THE LANDINGS OF DENMARK

FILING NO. 2 - UPDATED PLANS

COUNTY OF EL PASO, STATE OF COLORADO CONSTRUCTION PLANS

V2_Construction Drawings Redlines.pdf Markup Summary

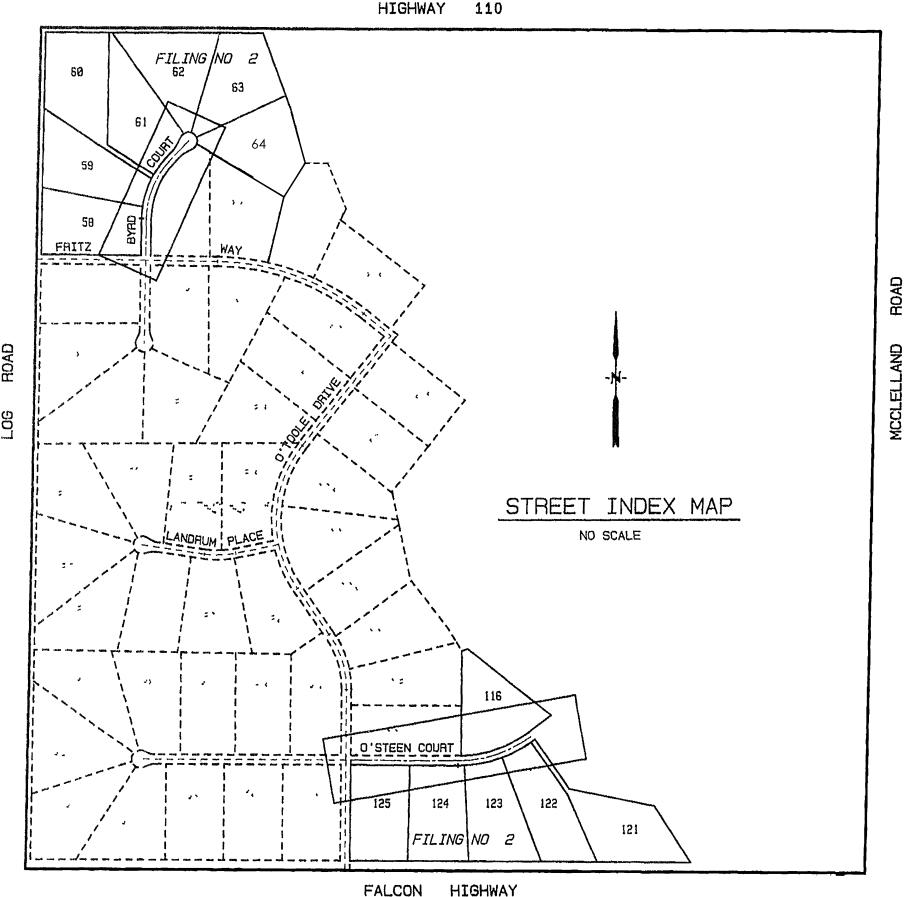
st the name of the eets that the cross

Length: 0 Area: 0 Volume: 0 List the name of the streets that the cross section

is applicable for

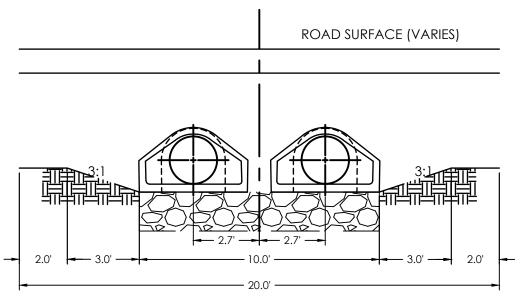
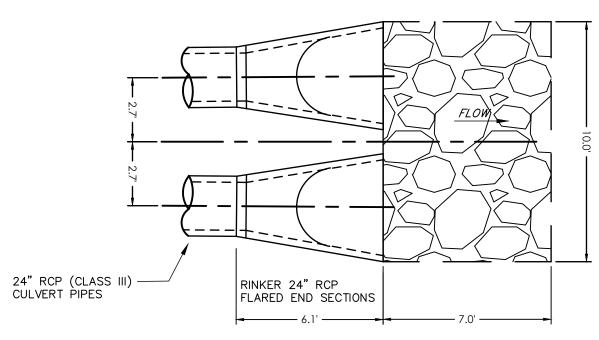
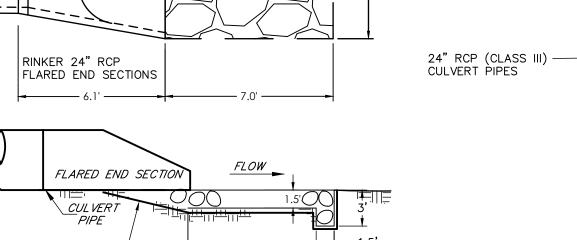
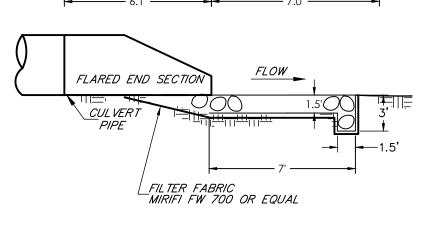
provi	de calcu	ulations	in DR
	CUL VERT PIPE DATA				CUL VEI	RT OUTLE	T APRON	DATA	
CUL VERT NO.	ROAD NAME	ROAD STATION	RC PIPE DIA	RC PIPE LENGTH (FT.)	FLARED END SECTION	W1 (FT.)	W2 (FT.)	L (FT.)	RIP— RAP TYPE
1	BYRD CT	N/A	2-24"	45	4	10	10	7	VL
2	O'STEEN CT	N/A	2-24"	48	4	10	10	7	VZ.

Length: 0 Area: 0 Volume: 0 provide calculations in DR

O'STEEN CT TYPICAL SWALE DETAIL

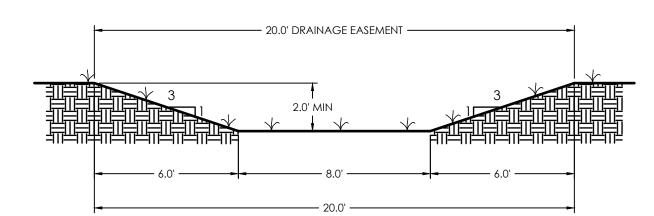
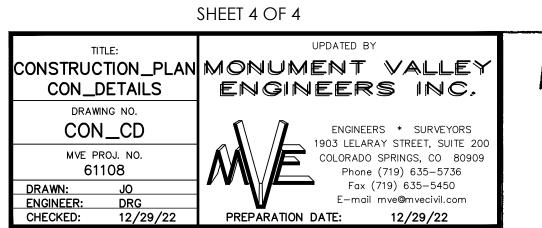
Provide detail for 10' section of O'Steen swale

Length: 0 Area: 0 Volume: 0 Provide detail for 10' section of O'Steen swale
